P-18685

S5987

ISSUE:-2

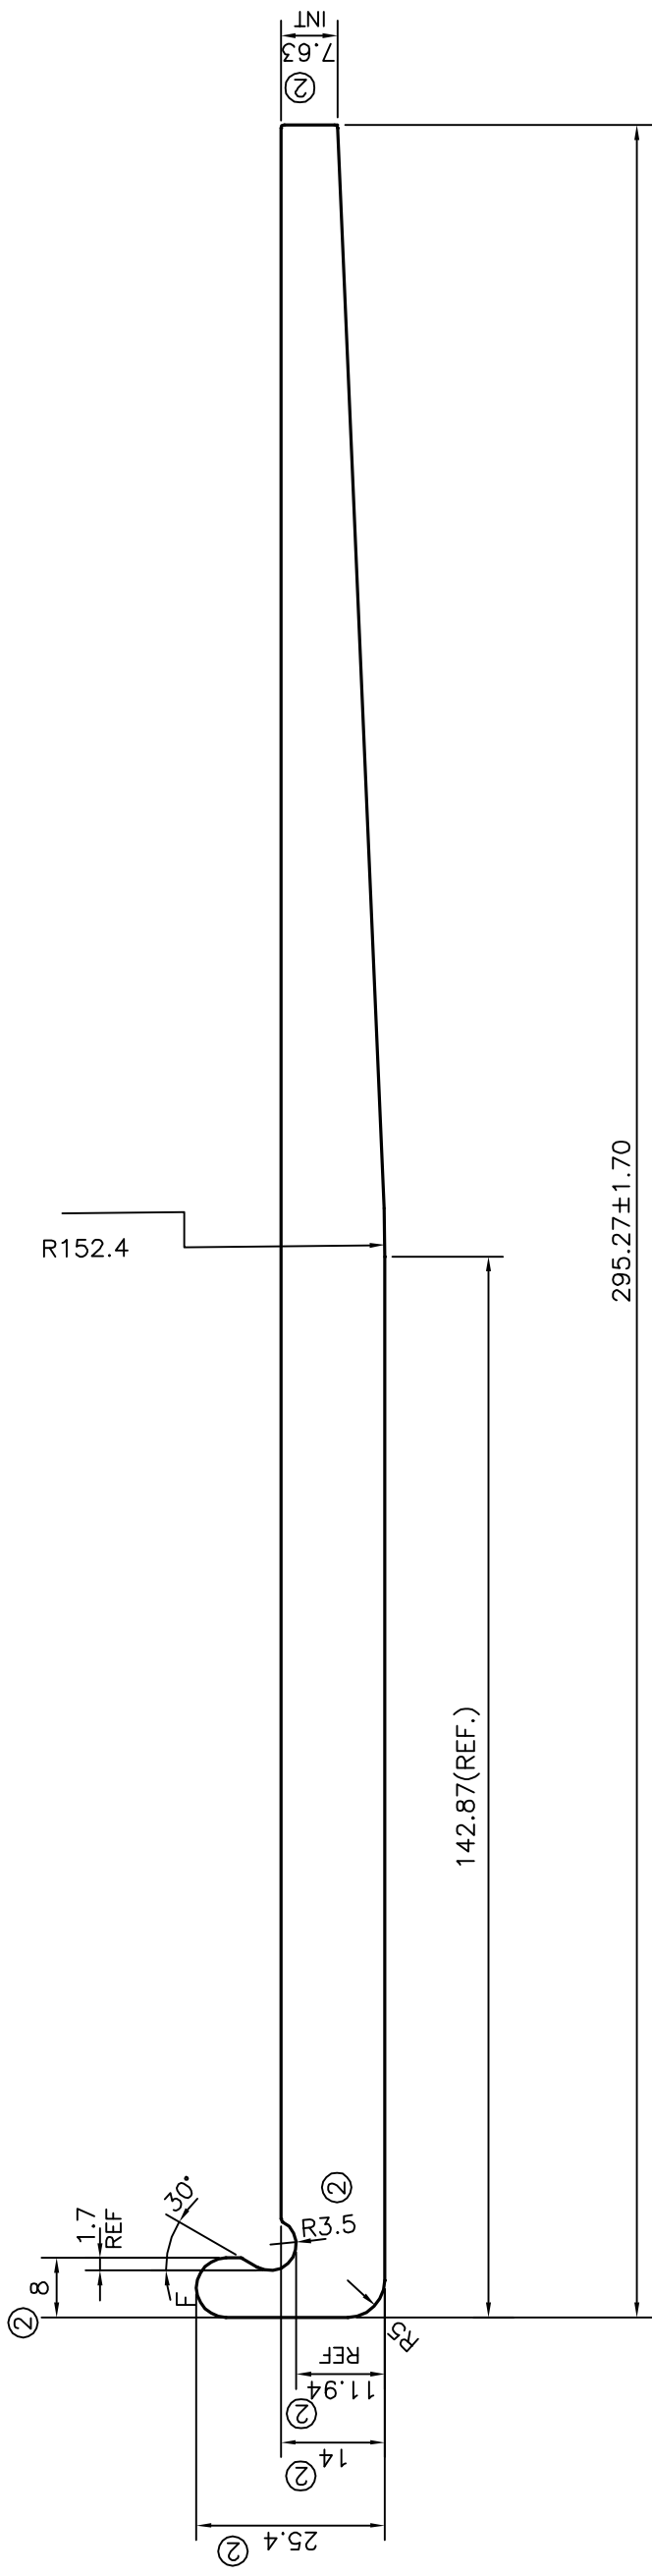
DIMENSION CHANGED FROM 26.25 mm TO 25.4 mm, 12.6 TO 14.0, 12.4 TO 11.94, 6.65 TO 7.63, 8.2 TO 8.0 & RADIUS ALSO CHANGED FROM R3.30 TO R3.5

WEIGHT ALSO CHANGED FROM 9.092 kg/m TO 10.049 kg/m
